Re: Petition for Modifications No. 1, Walnut Creek Energy Park (05-AC-02)

Petition for Modification No. 1

Minor Equipment Location Changes

Walnut Creek Energy Park

FIGURE 2.1-1A
Revised EME Walnut Creek Energy Park General Arrangement
Walnut Creek Energy Park Modification 1
Walnut Creek, California

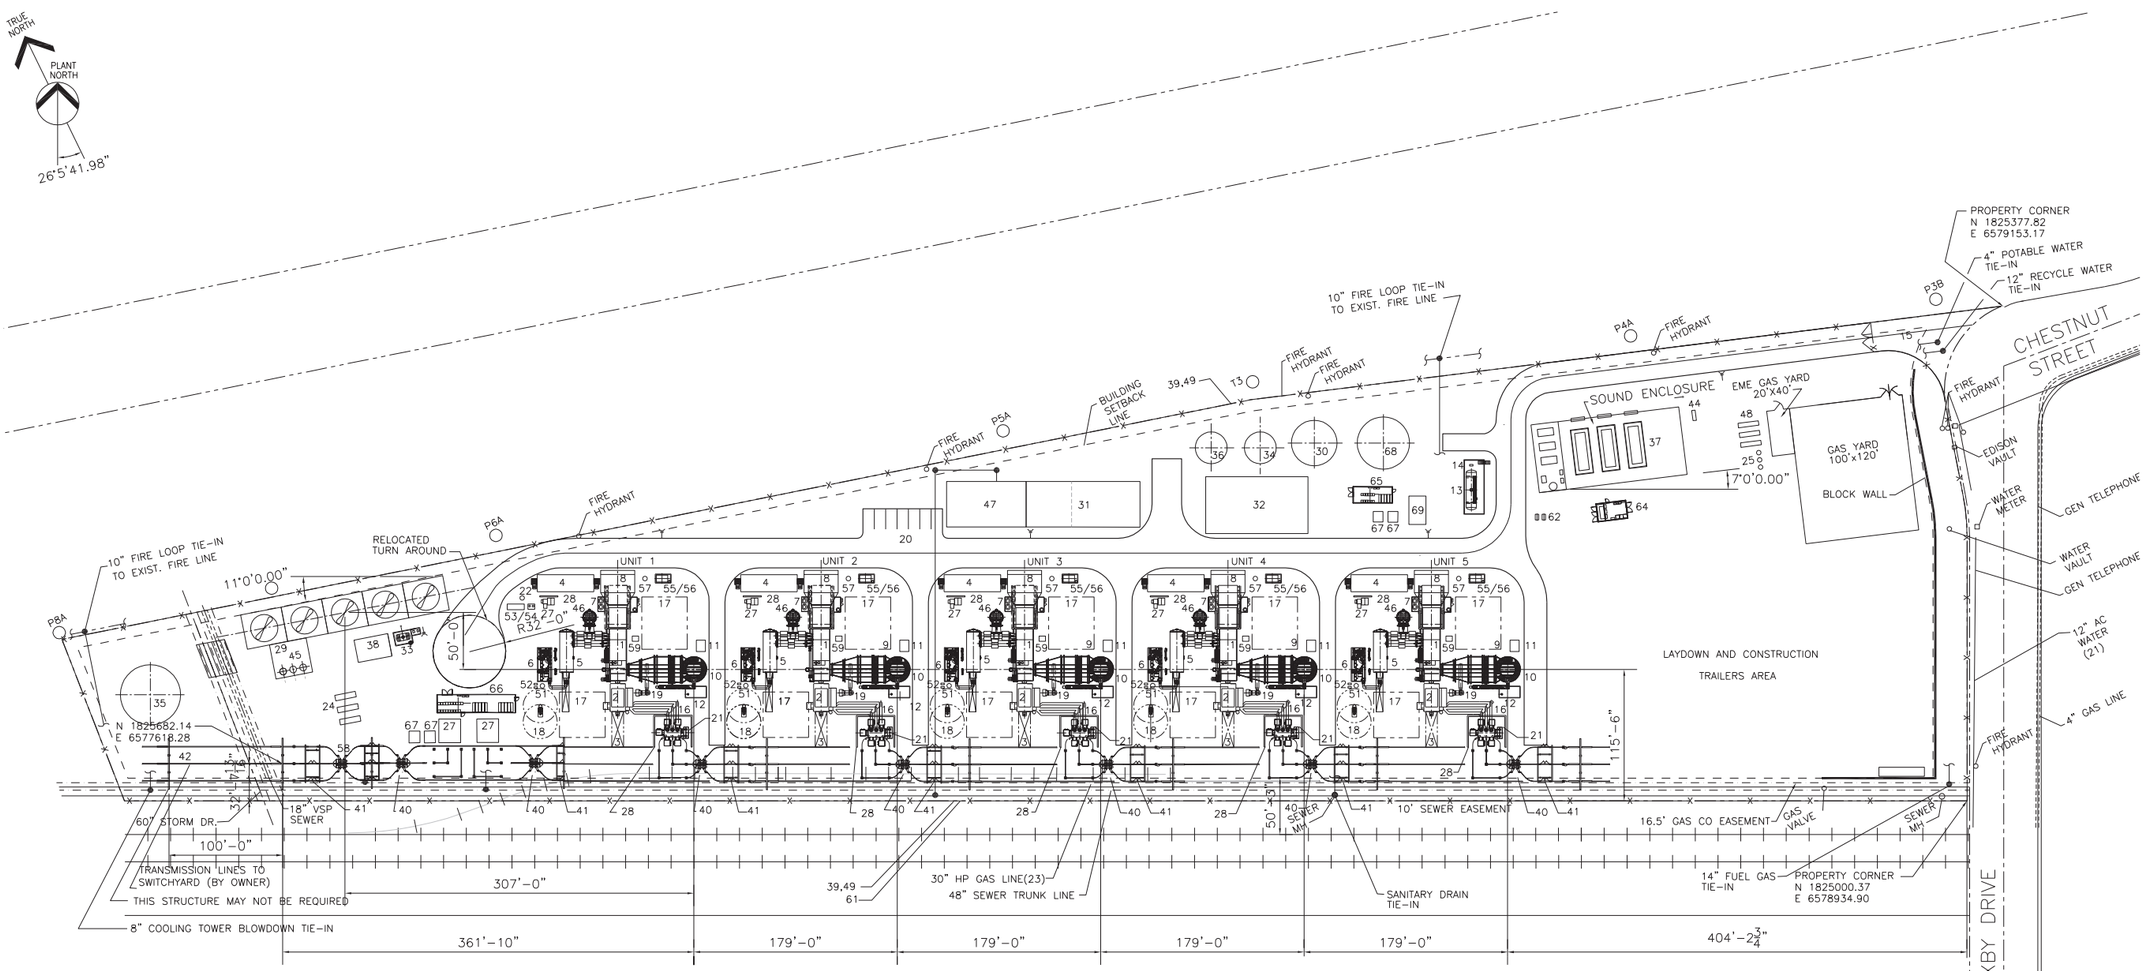
- Per direction from the Los Angeles County Fire Department, a turnaround circle will be added to the end of the facility driveway at the northern end of the site. To make room for the turnaround circle, the gas compressor building (37) will be moved from the western end of the project site, near the power distribution center (66), to the eastern end of the project site.

- A gas metering yard and filters will be located adjacent to the gas company yard on the east end of the project site.
- The cooling tower (29) will be moved approximately 120 feet east of the location identified in the AFC.

- The wastewater storage tank (35) will be added to the far west end of the site. The tank will be located near the cooling tower location.
- The control building and the warehouse/maintenance building will be combined into one building (47 and 31).

- The recycled chlorination tank will be removed.
- Miscellaneous small equipment will be added (51 to 68).
- Five high-side electrical breakers (40) will be added along the southwest side of the site.

FIGURE 2.1-1B
Comparison of the Proposed EME Walnut Creek Energy Park (WCEP) General Arrangement to the EME WCEP AFC General Arrangement
Walnut Creek Energy Park Modification 1
Walnut Creek, California

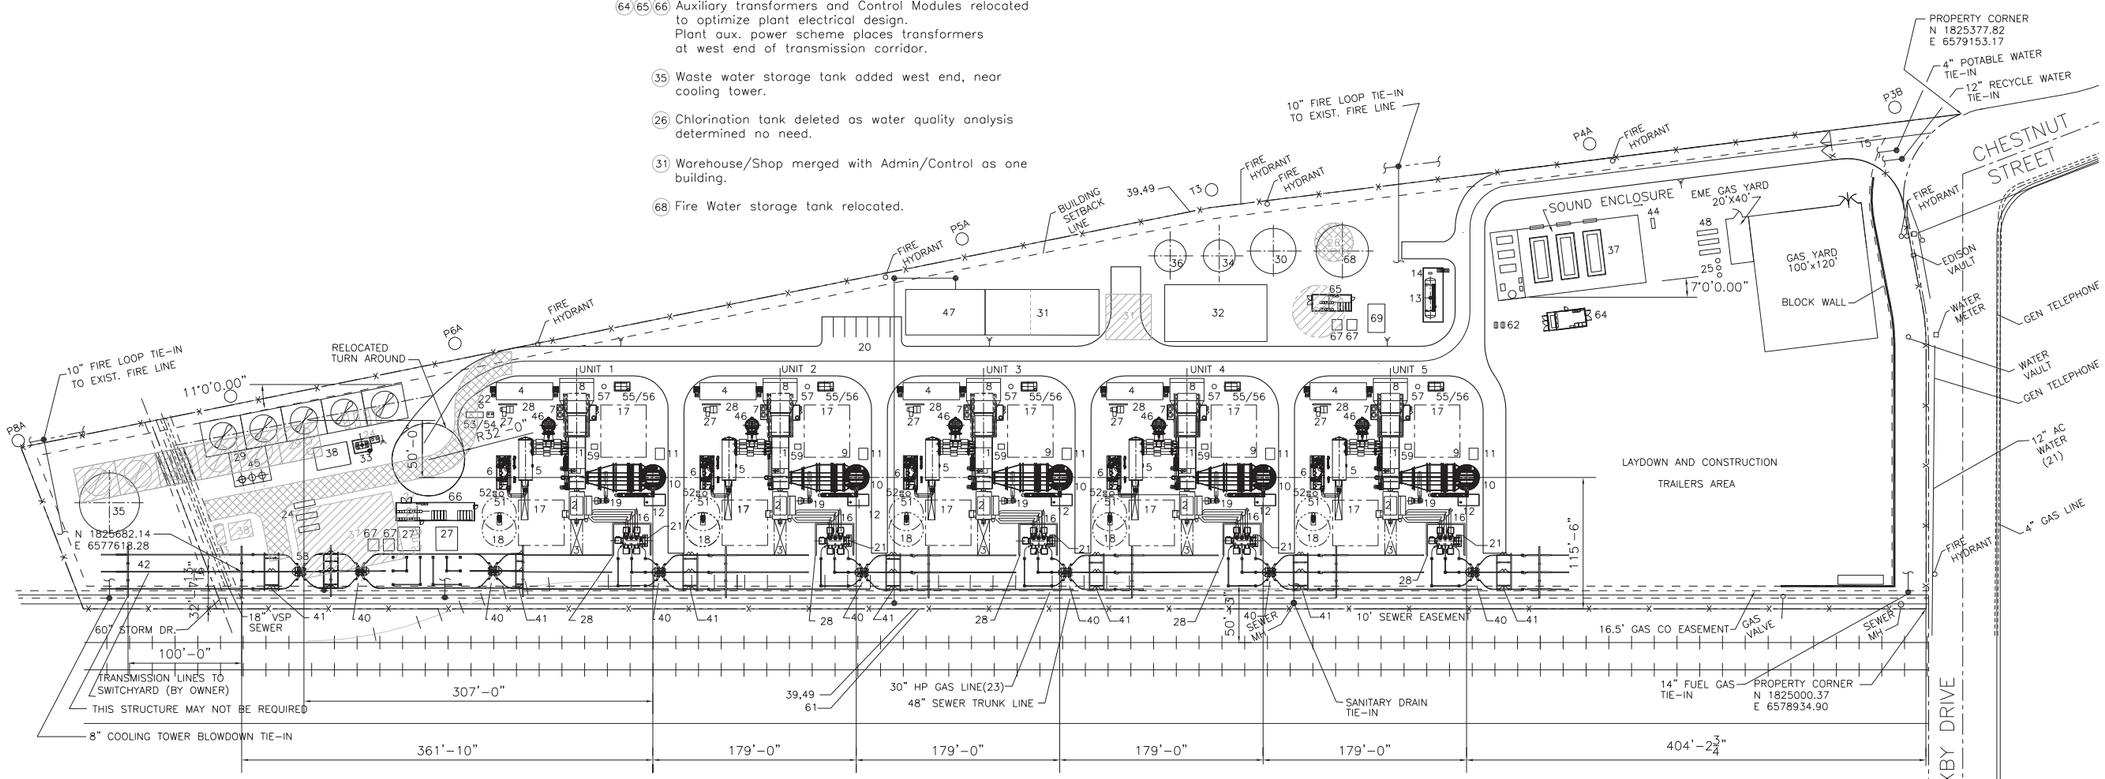
Roadway revised at west end to allow space for equipment relocation and provide traffic turn-around.

(24)(29)(38)(45) Cooling tower shifted east, off existing underground pipe corridor, pump basin placed on long side.

(25)(37)(48) Natural Gas equipment and enclosure relocated east and north.

(64)(65)(66) Auxiliary transformers and Control Modules relocated to optimize plant electrical design. Plant aux. power scheme places transformers at west end of transmission corridor.

(35) Waste water storage tank added west end, near cooling tower.

(26) Chlorination tank deleted as water quality analysis determined no need.

(31) Warehouse/Shop merged with Admin/Control as one building.

(68) Fire Water storage tank relocated.

FIGURE 3.1-1
Revised ISCST3 Building Location Plot

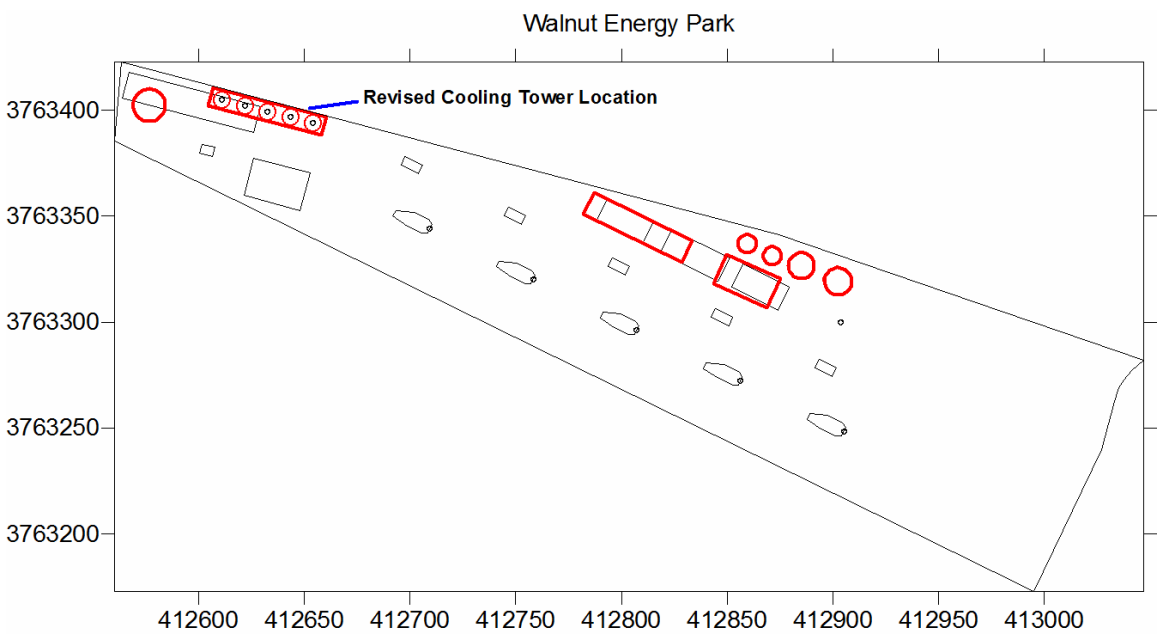
WCE proposes to move the WCEP cooling tower approximately 120 feet to the east, which would place it closer to the LMS-100 turbines. To assess the potential for changes to the project air quality and health risk impacts, the new cooling tower location was analyzed with both the Industrial Source Complex Short Term Model (ISCST3) as well as the Hotspot Analysis Reporting Program (HARP). As part of the inputs into both models, the Building Profile Input Program (BPIP) was also used to calculate the revised structure dimensions based on the new location of the cooling tower. No other changes to emissions or source locations are proposed for the WCEP. The revised cooling tower location used in the ISCST3 dispersion modeling analysis is depicted in Figure 3.1-1.

In order to determine the potential for a revised magnitude and location of the maximum impacts for each pollutant and averaging period, the ISCST3 model was used to directly compare the potential for changes. Based on output from BPIP, the revised cooling tower location will have minimal effect on the turbine's air quality impacts. Table 3.1-1 summarizes maximum-modeled concentrations for each criteria pollutant and associated averaging periods. The results of the modeling analysis demonstrate that the 1-hour and 8-hour carbon monoxide (CO) concentrations, as well as the annual nitrogen dioxide (NO_2) concentrations, would decrease with the proposed project modification. All other pollutants and averaging times would have the same impact as previously modeled in the AFC. Similarly, the turbine startup and commissioning activities would result in no changes to the modeled concentrations. Thus, for air quality impacts, no significant changes in air emissions impacts are expected to occur as a result of the change in the cooling tower location. A compact disc containing the modeling input/output files will be submitted under separate cover.
